DESIGN REVIEW BOARD DECISION

FILE NUMBER: DRV22-00693
PROJECT NAME: 601 Market St
APPLICANT: Todd Kilburn, Kilburn Architects
PROJECT PLANNER: Kyle Cotchett, Associate Planner

DESIGN REVIEW RESPONSE

1 Site Plan - Landscape Modification
 Scale: 1/16" = 1'-0"

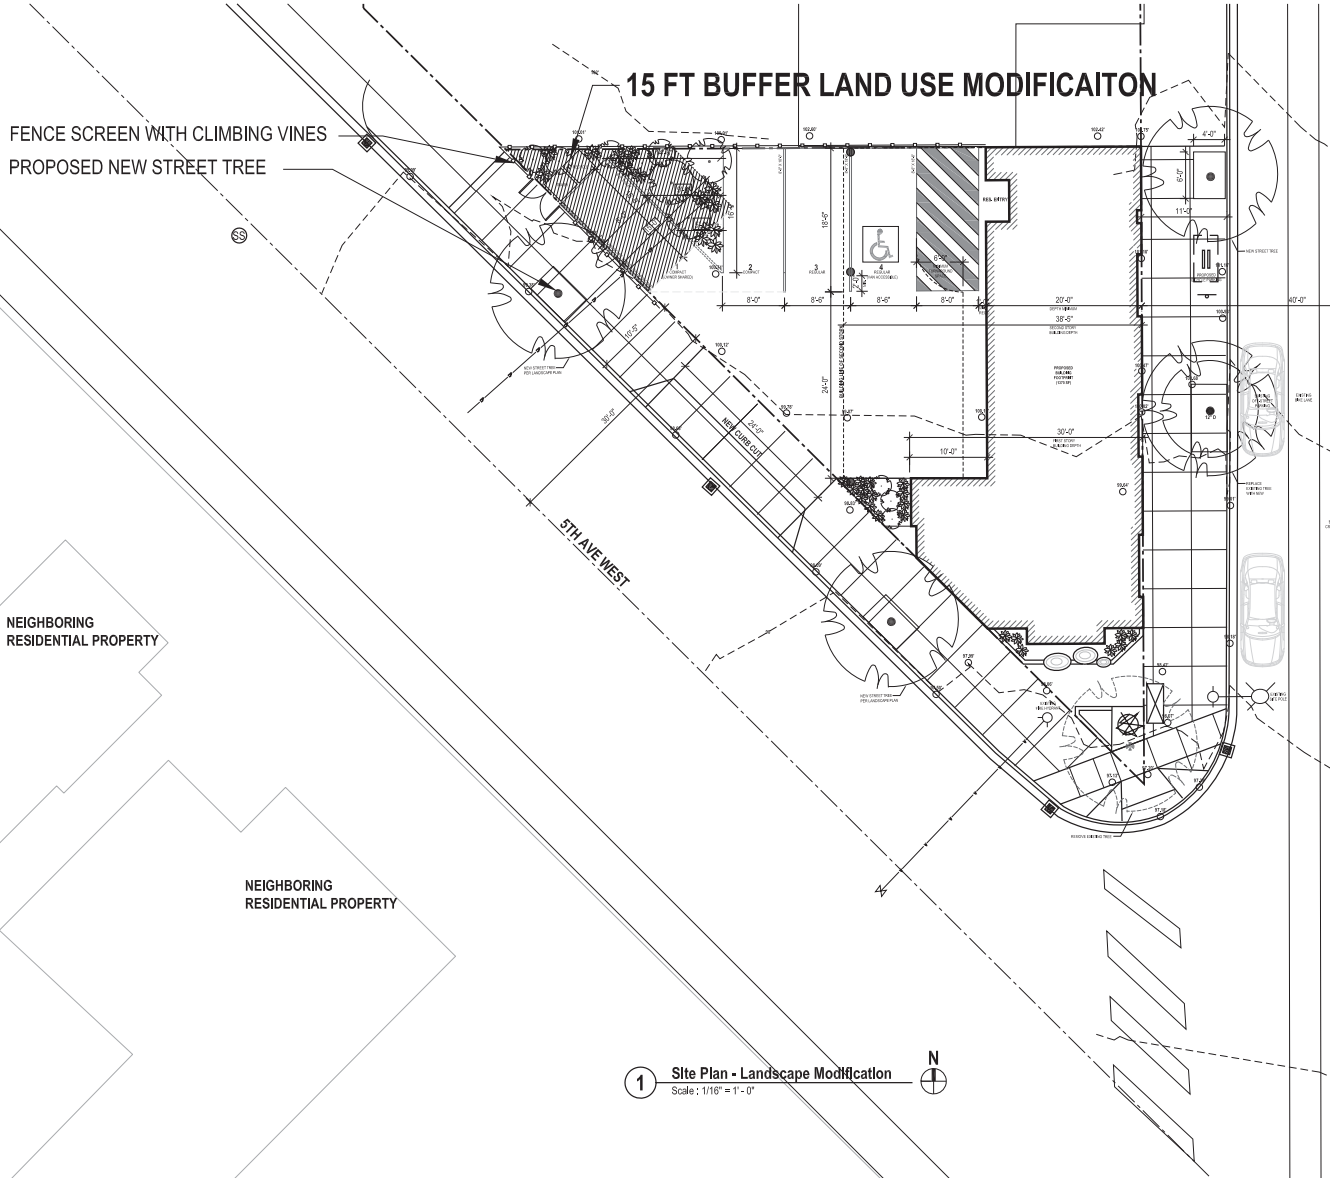
6. Include building sections showing not only the proposed structure, but also neighboring buildings.
7. Finalize the landscape plan making sure to focus on the parking screening required landscape buffers, and the pedestrian space.

We are requesting a land use modification 95.46.(b) for the required 15 ft buffer at the parking off 5th Avenue. KZC 95.46.(b) states due to the existing topography, other characteristics of the subject property, and the distance of development from the neighboring property, we feel it decreases or eliminates the need for buffering. Due to the challenging characteristics of the triangular site, we first obtained a parking modification **TRAN20-0057**. With the approved parking, we were able to derive our building footprint while meeting minimum requirements in the Kirkland Zoning Code. The 15ft buffer would make parking infeasible due to the triangular site and required parking turn around radius, shown from the approved parking modification (**TRAN20-0057**), to buffer the neighboring residential homes across the street. The 15ft buffer would also make it infeasible to create a useable office space on the ground floor, as well as achieve the 20-30ft required building depth. We have provided a 6ft fence with climbing vines and new street tree, and feel it will be sufficient to provide the visual buffer screen for those units. We have also provided an average of 9ft (or 5ft - 14.5ft) landscaping between the angled stall and the other stalls to provide as much landscape buffering as feasibly possible.

7. The landscape buffer exhibit, landscape screen wall fence detail sheet, and the landscape plan are included in the proposal. Parking screening to comply with Fig. 95.45.B, with 5ft high landscaped fencing and climbing vines.
